Response to Reviewer 1

The study combines multiple existing wastewater treatment plant (WWTP) datasets, supplementing available information with additional (inferred) plant characteristics, to produce a consistent and coherent global dataset of wastewater treatment plants. Information captured within the dataset includes both geographical location and important plant characteristics such as flow rates and treatment level. The authors calculate an average wastewater treatment plant dilution factor, and link WWTP outfall locations to the river network, to calculate the length of the stream network downstream of WWTPs as a basic indicator for identifying areas of potential environmental concern. Overall, I believe this work to be both of high quality and interest for the scientific community. The manuscript clearly describes the dataset and is mostly well written, although I would recommend some edits to improve readability (particularly shortening sentences!). Therefore, after some revisions, I would recommend publication in ESSD. Please see my detailed comments below for my recommendations on how the manuscript could be further improved.

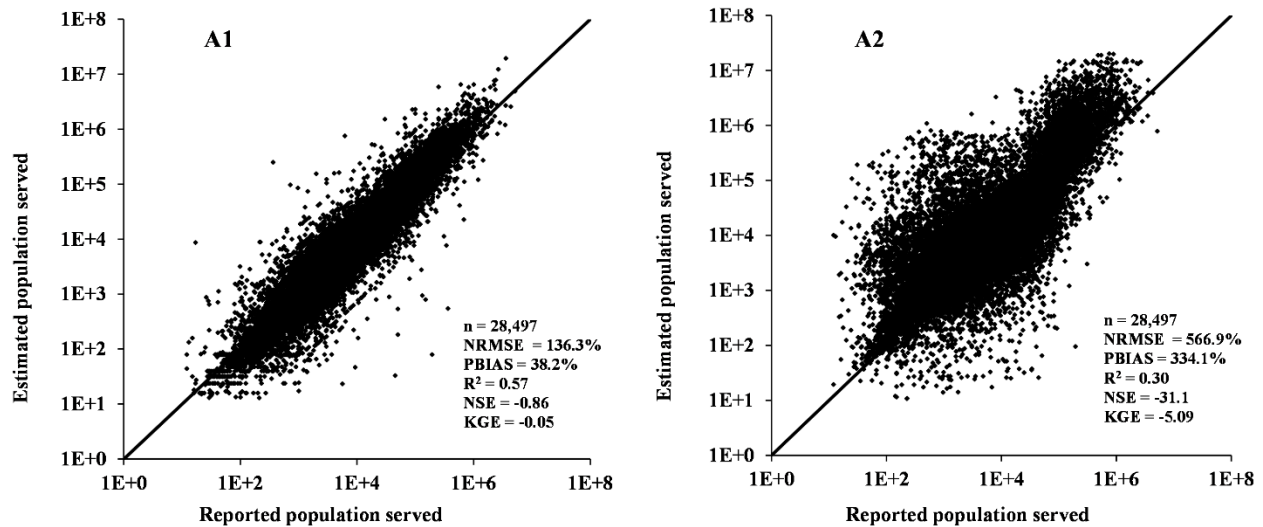
For estimating the missing attributes for "population served"; I suggest the authors conduct and reflect upon the sensitivity of their results to their assumptions. The authors select the minimum value calculated from the three methods, but how do the results look if one method is used consistently instead? Also important to reflect upon the uncertainty of these derived attributes in general.

The combination is used to reduce uncertainties of the individual methods, and we do agree that showing the sensitivity of results for each method could reinforce our decision to combine them. We therefore conducted an additional sensitivity analysis and added a section in the Supplement to present and discuss this analysis. To inform the reader about this addition, we added a reference in parenthesis in the main manuscript at line 285:

When applied to all existing validation data, approach A1 on its own (Fig. S2, left panel) shows a similar scatter plot and comparable goodness-of-fit parameters as the final method (Fig. 4a in main manuscript). This is because A1 provided the minimum (i.e., final) value more frequently than the other approaches in this evaluation (70%). Approach A2 (Fig. S2, right panel) resulted in more bias towards overestimation, especially for smaller WWTPs. However, even if approach A1 was generally superior to A2, approach A1 requires that a reported treated wastewater discharge value exists, which is not the case for 6,542 records of HydroWASTE.
